Imray Correction Notice

ICC52-2

Chart C52 WGS 84

Edition 2015

Block correction for C52 (Plan G)
ILNW 418/16

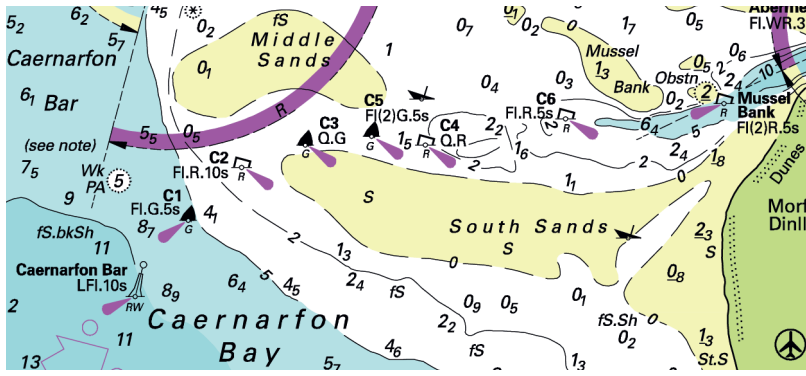
8 Caernarfon Bar (Plan G)

Insert accompanying block correction centred on 56°06'·92N 4°23'·08W (ILNW 418/16)
